Item Name: Strut

ENGINEERING CHANGE NOTICE NO.

DWG NO. 646.3500

DWG TITLE: STRUT

ENGINEERING CHANGE NOTICE NO.

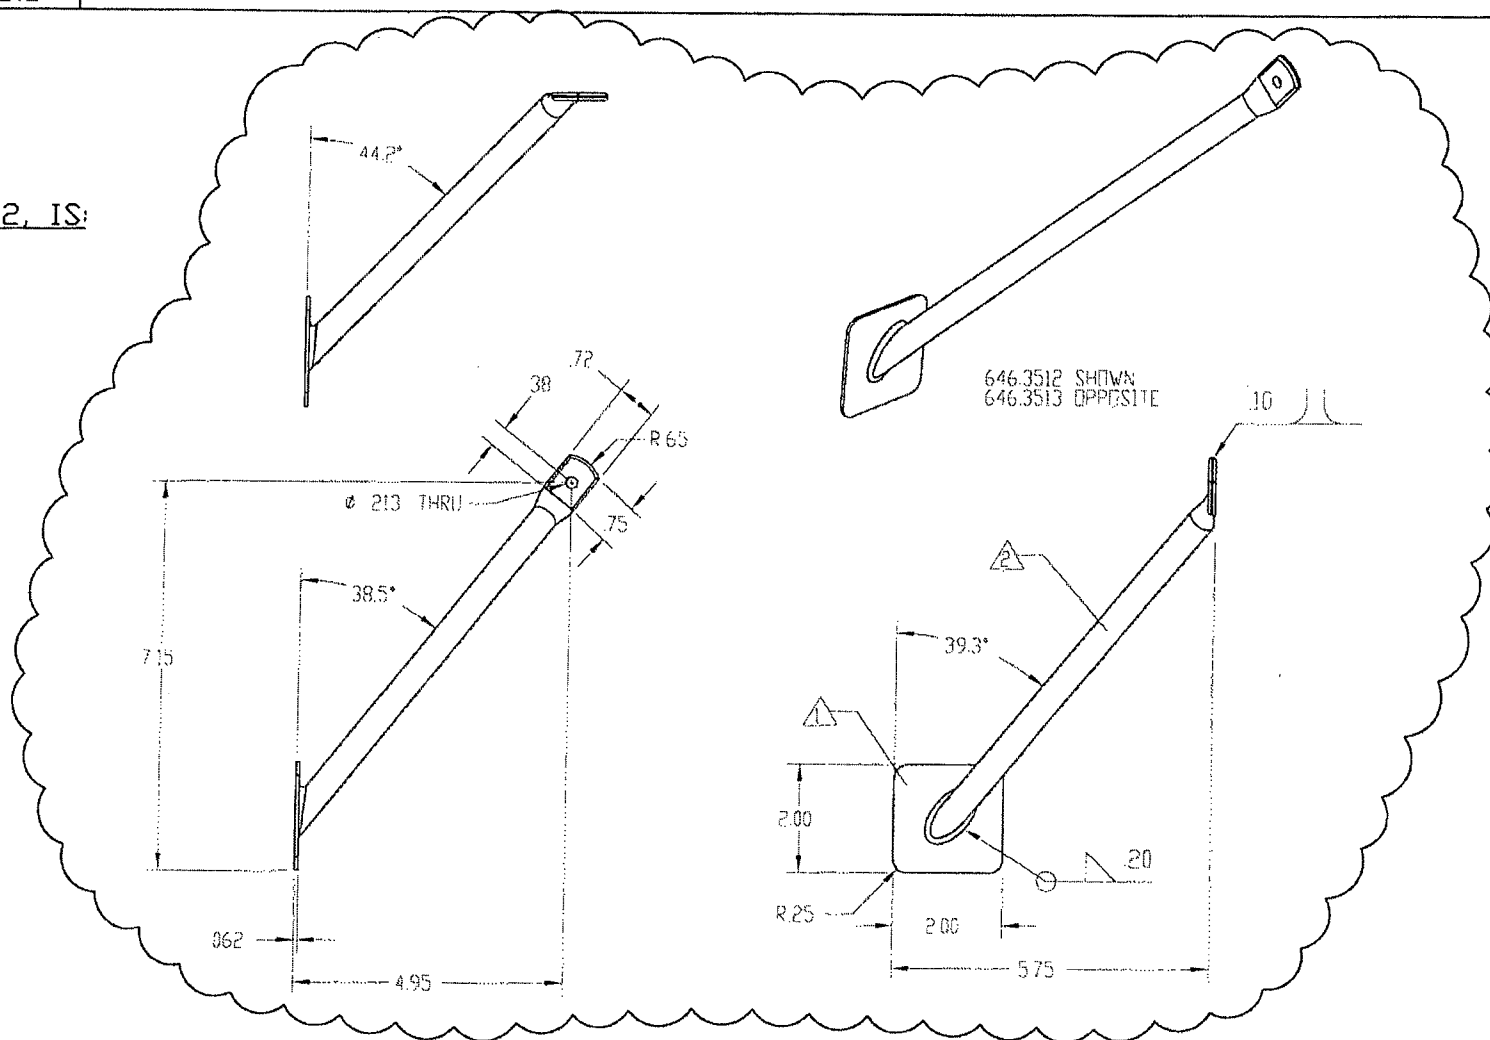
REASON: REVISED ANGLE OF 646.3512 & 646.3513 FOR BETTER FITMENT

SHEET 2, IS:
